Meeting: TAC
Date: August 5, 2024
RE: 100 Durgin Lane

Dear Members of the Technical Advisory Committee,

Part of page 13:

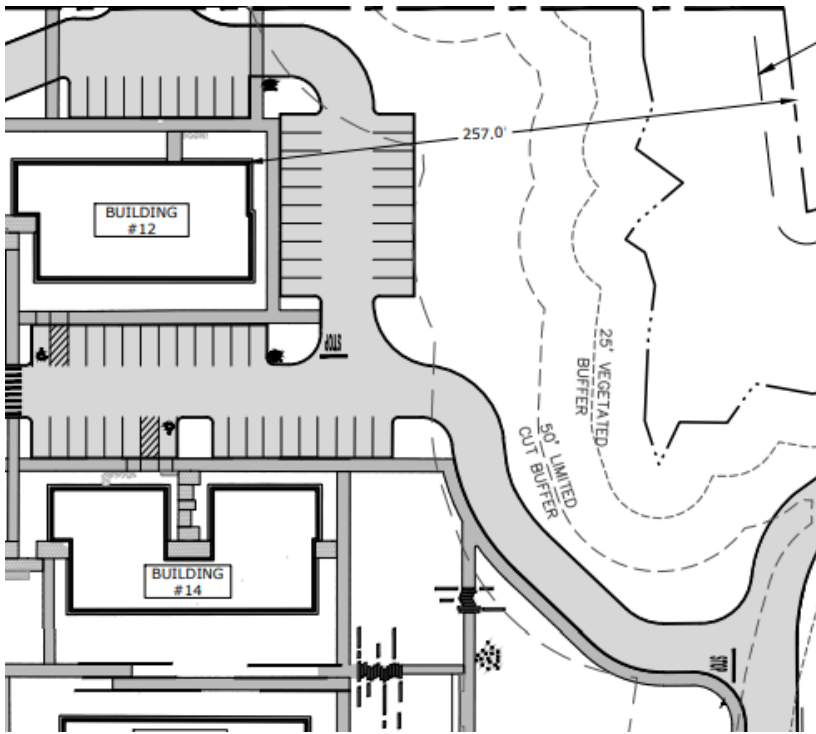
It states in the Noise Report that the park on the southern end (TAC Packet page 534) of the complex near Rt 4 will require noise abatement. However, the park on the northern end which sits closer to Rt 4 is not mentioned at all. Please review page 13 in the TAC Packet. It clearly shows both parks and how much closer the northern park is to the Spaulding. Please ask this issue be addressed.

It was suggested the "park" on the northern end be turned into a "natural" area with viewing but no access for humans or pets (see above). *Doing this would remove the need for noise abatement on the northern end of the complex.* Some conservation suggestions could assist Fire/EMS. The idea of slightly changing the configuration of the road/driveway (see below) parallel to the northern park area to a more "L" shape (coming from Motel 6 shortcut and taking a right past the rain garden and buildings 14 and 17). This could remove the road completely from the 100' buffer and allow for easier access by Fire and Emergency vehicles. To make it even easier the road could attach to the driveway by Building 12 by removing 3 parking spaces (see below). Light dimming was suggested which is currently not shown on the lighting table and solar was discussed. Other issues were discussed as well, perhaps the minutes could be presented to TAC for review.
